PD Modification Application: PRS 24-0205

BOCC Land Use Meeting Date: February 13, 2024

Development Services Department

Request: Minor Modification to PD 19-0745

8.2 Proposed Site Plan (Full): Option 1

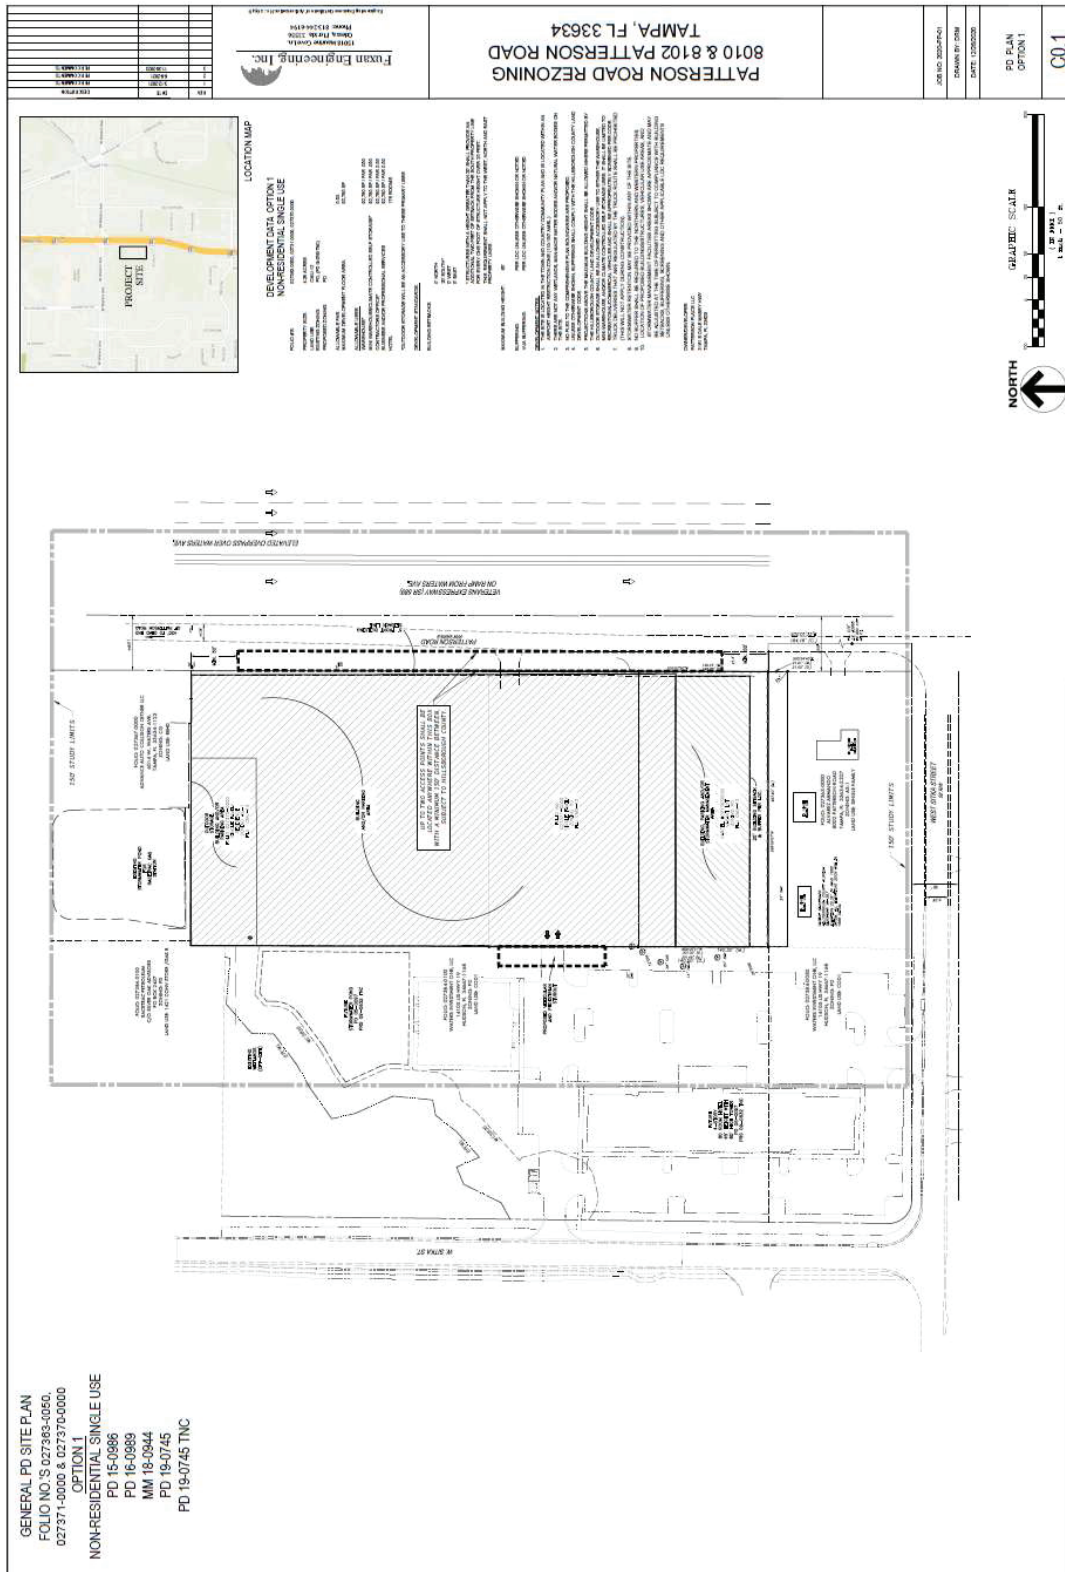
- Revise Option 1, “20’ Building Setback & Buffer per LDC” to “20’ foot landscaped buffer with Type “C” screening”;
- the developer shall revise Option 4;
- and the leftmost Option 2 graphic to show the internal transportation system connecting to the proposed western stubout.

8.2 Proposed Site Plan (Full): Option 2

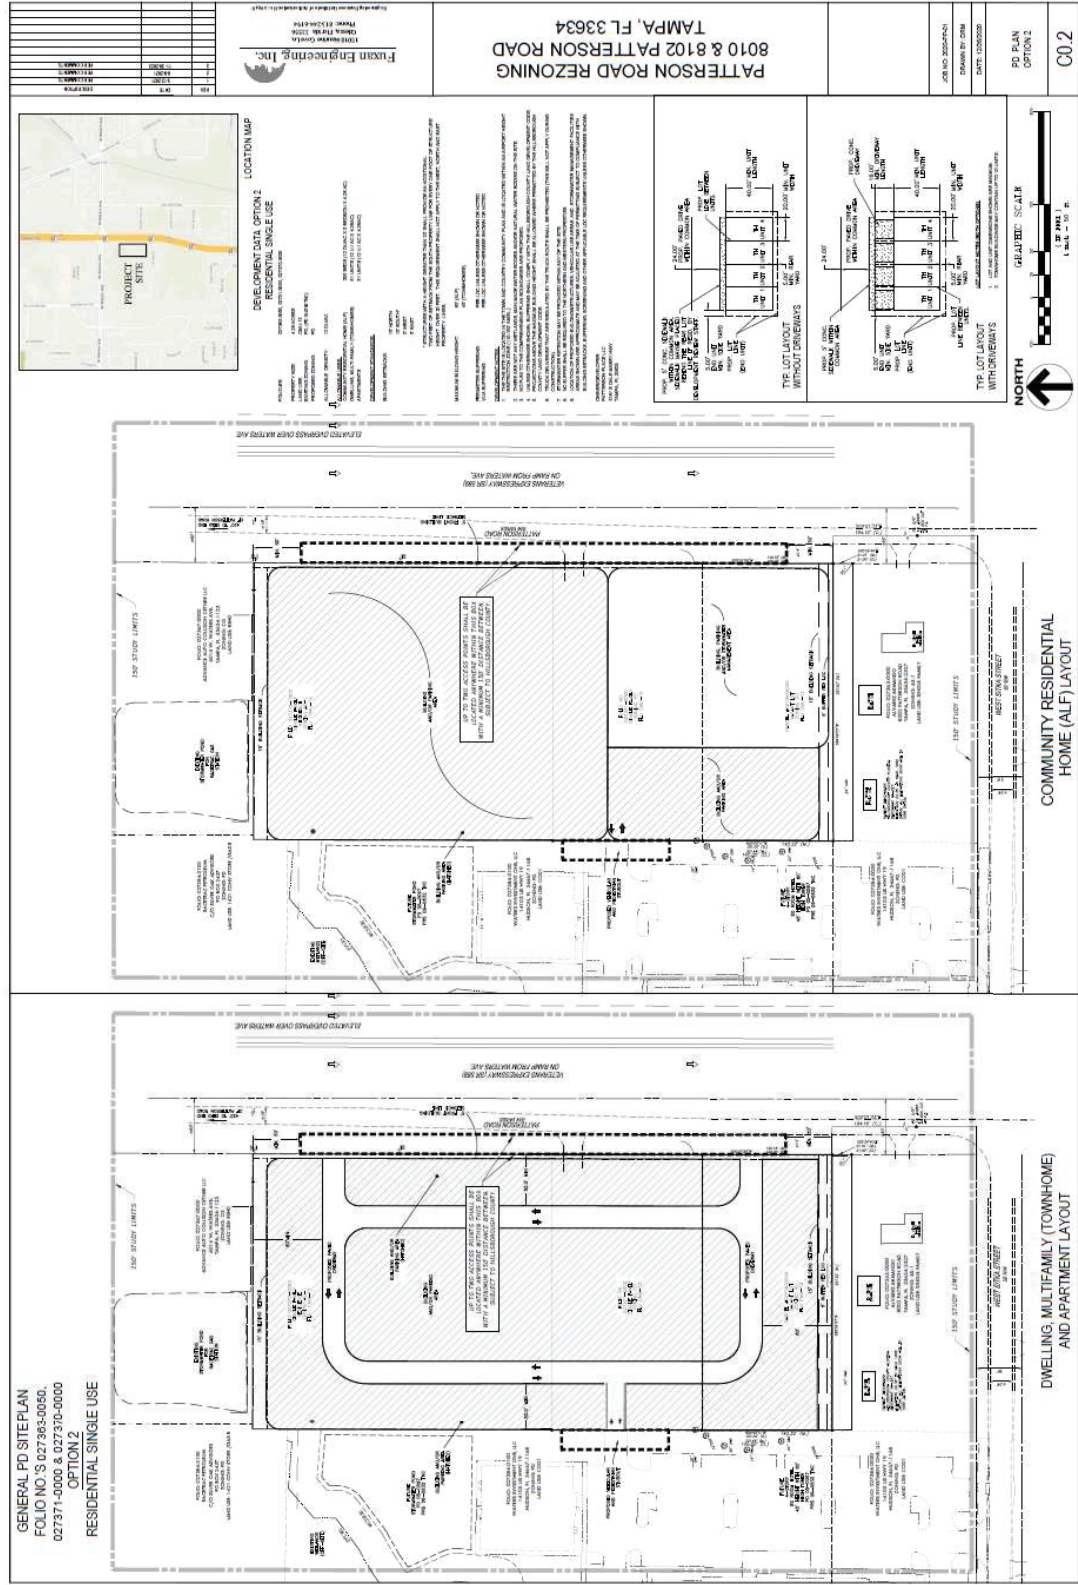
- Prior to PD site plan certification, the developer shall revise Option 4 and the leftmost Option 2 graphic to show the internal transportation system connecting to the proposed western stubout.

PROP. PATTERSON ROAD SECTION NORTH OF SITKA ST. - EXHIBIT 3

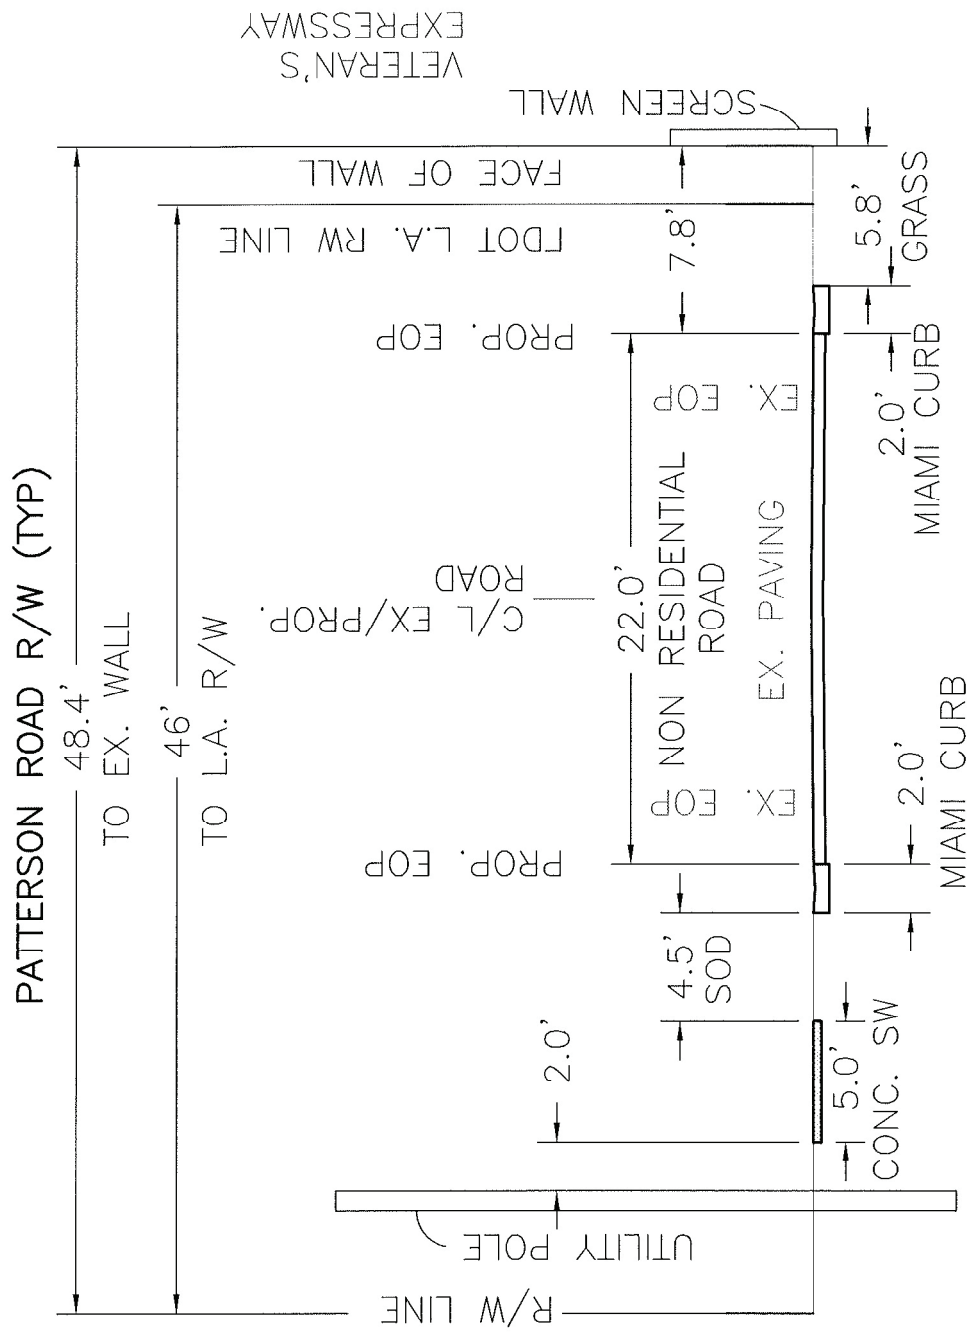
- Shift the proposed sidewalk to provide 2 ft. flat area between the back of sidewalk and RoW line, 1 ft. is possible if it helps with existing power pole conflicts.

- Exhibit 3, label curb type, assume miami.
*Response: The curb has been labeled as Miami Cub. **Confirmed***
- Recommend shifting the roadway alignment west to provide 6 ft. min from the EoP (not back of curb) to the cmu wall, considering its 10.4 ft. today and the added traffic.
*Response: Given the reduced lane widths indicated below, we can maintain the existing road center line and provide over 7' from the eop to the face of the wall. Maintaining the center line will make for a better transition from the new to the existing road way as Patterson Road continues north and ties into W. Sitka Street south of the project. **Good idea***

- May want to consider 11 ft. travel lanes, can act to calm traffic/reduce speeds – unless heavy truck traffic is expected, I don't recall.
*Response: The PD has restrictions on heavy truck traffic & we agree that 11' travel lanes are appropriate for the project and have implemented the change. **Confirmed***

- Its noted, due to the Veterans, there are no pedestrian destination on the east side of Patterson Rd within the improvement limits, supporting no east side sidewalk.
*Response: We agree and appreciate your support for the exception. **Confirmed***

Response: The poles only impact the sidewalk by approximately 0.8', leaving 4.2' of clearance which meets ADA standards. It is my professional opinion that the sidewalk will work along the RW line. See TS-3 note 3, 2 ft. flat is specified, can go to 1 ft. flat (both sides of sidewalk) if added as a DE element.

PROP. PATTERSON ROAD SECTION NORTH OF SITKA ST. - EXHIBIT 3

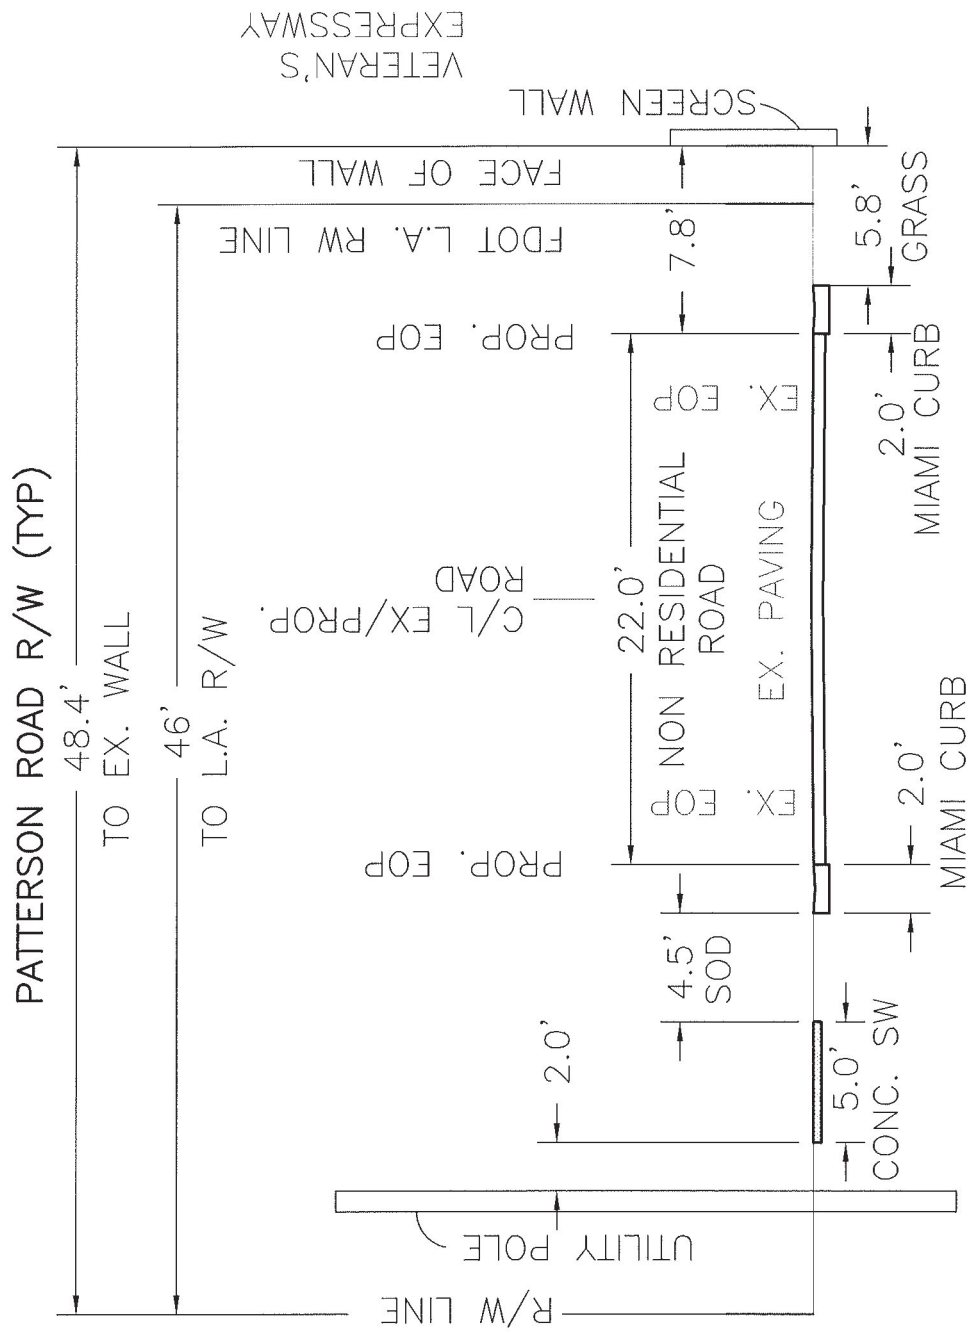
- Shift the proposed sidewalk to provide 2 ft. flat area between the back of sidewalk and RoW line, 1 ft. is possible if it helps with existing power pole conflicts.

- Exhibit 3, label curb type, assume miami.
*Response: The curb has been labeled as Miami Cub. **Confirmed***
- Recommend shifting the roadway alignment west to provide 6 ft. min from the EoP (not back of curb) to the cmu wall, considering its 10.4 ft. today and the added traffic.
*Response: Given the reduced lane widths indicated below, we can maintain the existing road center line and provide over 7' from the eop to the face of the wall. Maintaining the center line will make for a better transition from the new to the existing road way as Patterson Road continues north and ties into W. Sitka Street south of the project. **Good idea***

- May want to consider 11 ft. travel lanes, can act to calm traffic/reduce speeds – unless heavy truck traffic is expected, I don't recall.
*Response: The PD has restrictions on heavy truck traffic & we agree that 11' travel lanes are appropriate for the project and have implemented the change. **Confirmed***

- Its noted, due to the Veterans, there are no pedestrian destination on the east side of Patterson Rd within the improvement limits, supporting no east side sidewalk.
*Response: We agree and appreciate your support for the exception. **Confirmed***

Response: The poles only impact the sidewalk by approximately 0.8', leaving 4.2' of clearance which meets ADA standards. It is my professional opinion that the sidewalk will work along the RW line. See TS-3 note 3, 2 ft. flat is specified, can go to 1 ft. flat (both sides of sidewalk) if added as a DE element.
